Origination Form
Proposed Revisions to a Standard Plans Index

Originator:	Turley, Joshua	Index Number:	455-030
Date:	5/15/2025	Sheet Number(s):	Sheet 1
E-mail:	Joshua.Turley@dot.state.fl.us	Index Title:	30" SQUARE PRESTRESSED CONCRETE PILE

30" SQUARE PRESTRESSED CONCRETE PILE

INDEX
455-030

ELEVATION

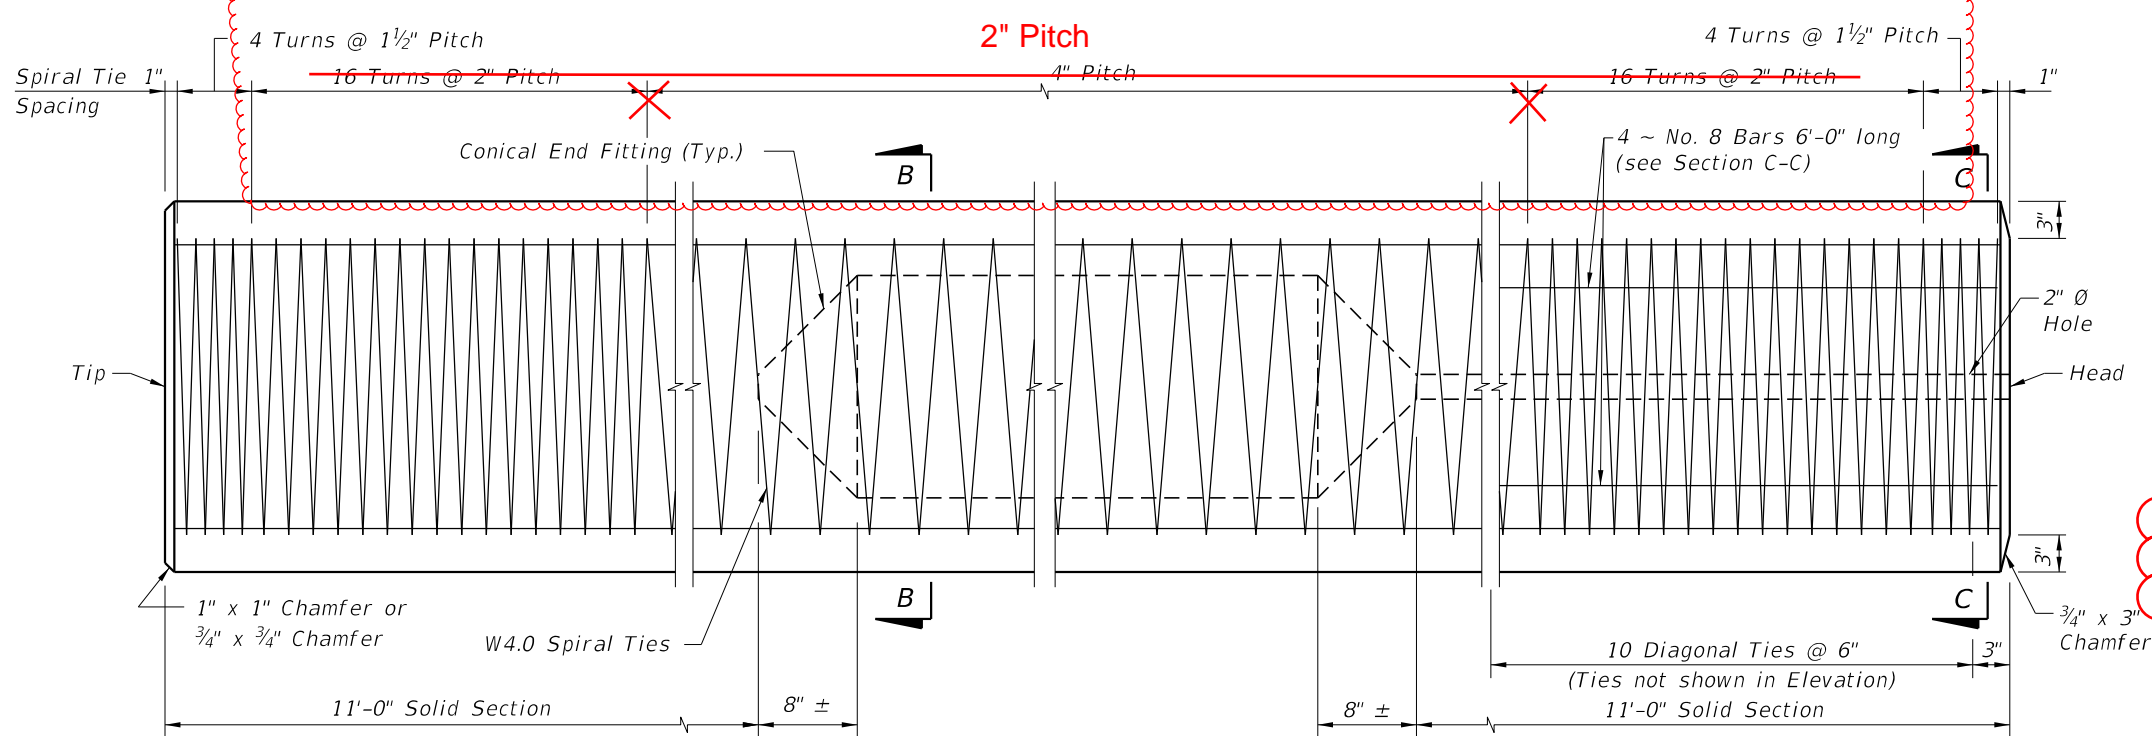
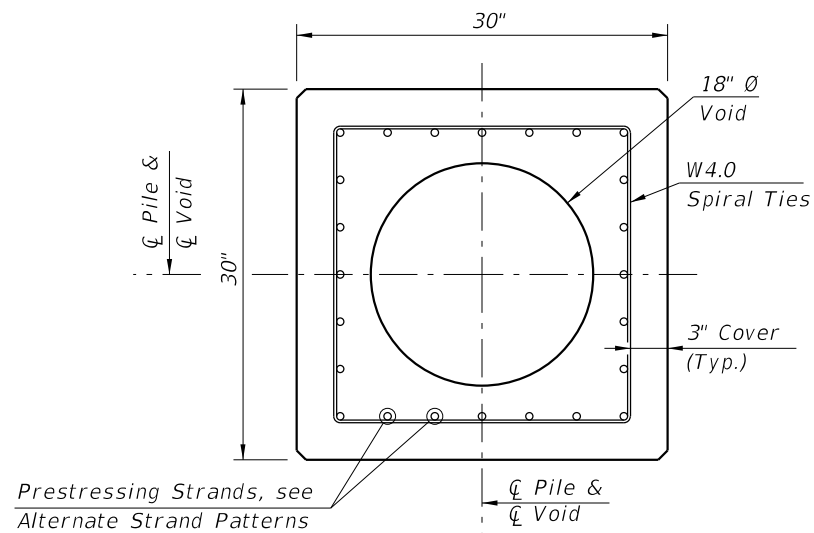
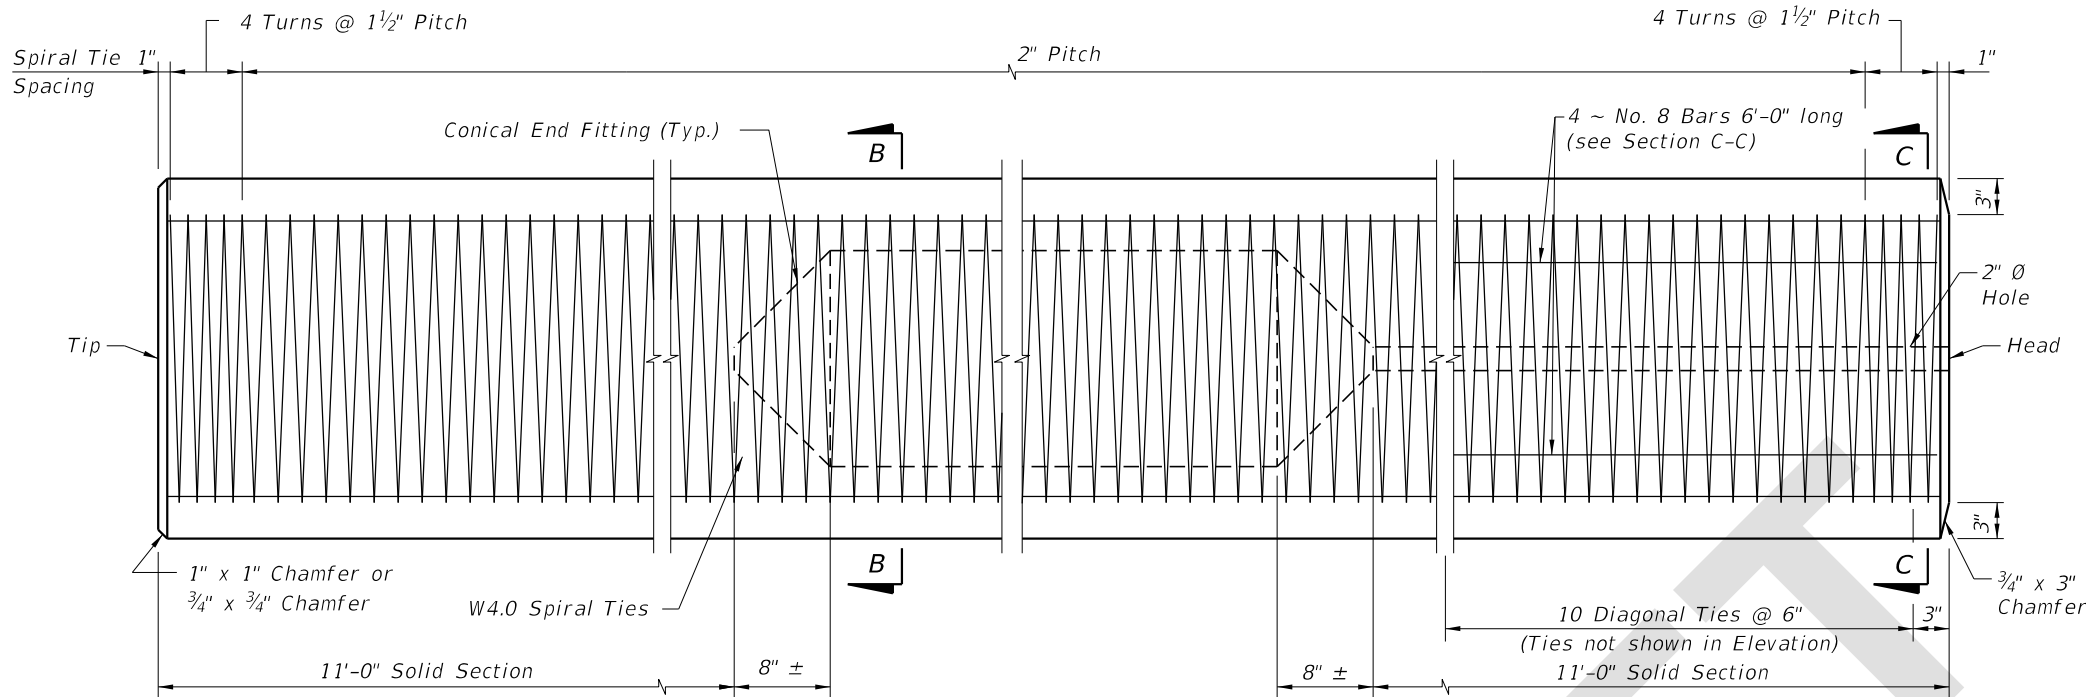
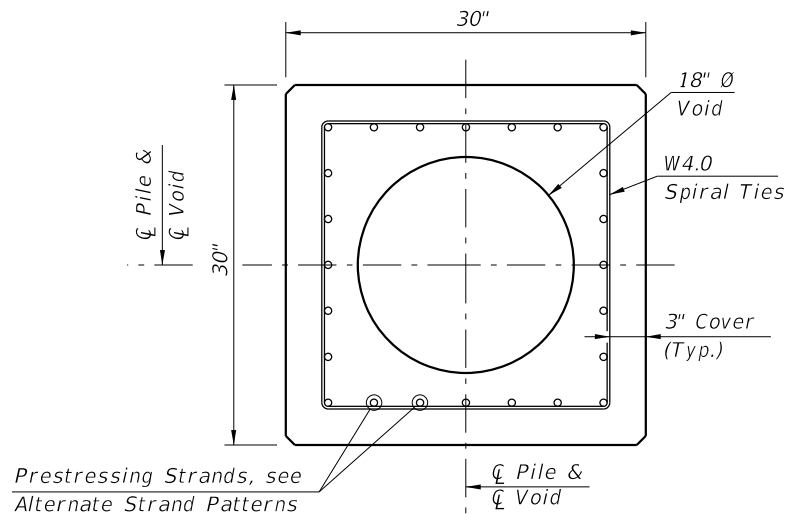
Sheet 1: Changed pitch spacing for the spiral ties; Changed SECTION D-D note "See unplanned reinforced CIP pile splice or non-drivable unplanned reinforced precast pile splice detail".

Vertical cracking has been observed in hollow core prestressed concrete piles, including 30-in. voided square HMC and conventional piles, and 60-in. hollow cylindrical piles, during installation and service. To address cracks frequently occur within the 4" stirrup pitch zone, a reduction in stirrup pitch to 2" is proposed to help mitigate cracking in these areas.

SECTION D-D
(See Non-Drivable Unforeseen Reinforced Precast Pile Splice Detail)

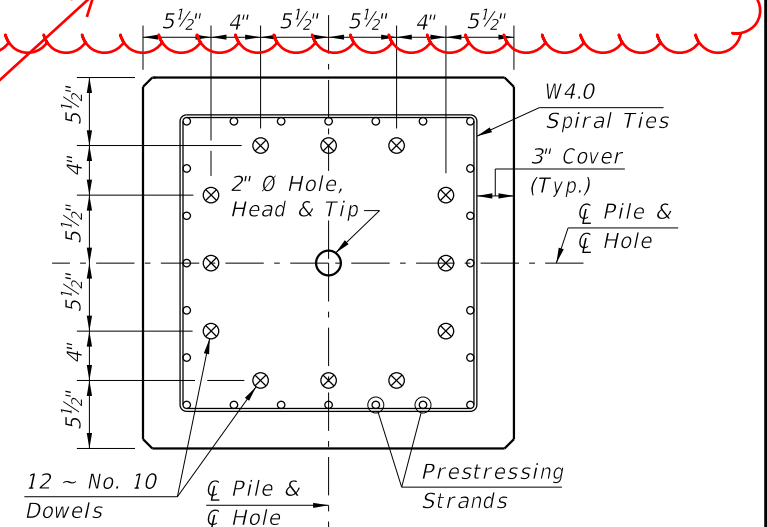
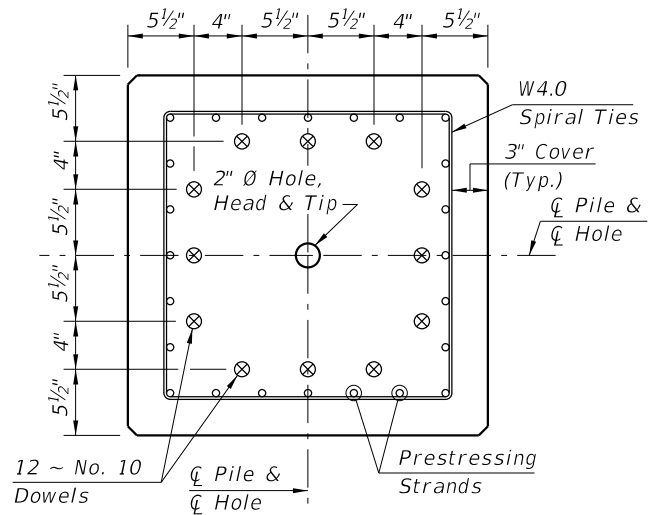
CHANGED:
See Unplanned Reinforced CIP Pile Splice or Non-Drivable Unplanned Reinforced Precast Pile Splice Detail

SECTION D-D
(See Unplanned Reinforced CIP Pile Splice or Non-Drivable Unplanned Reinforced Precast Pile Splice Detail)
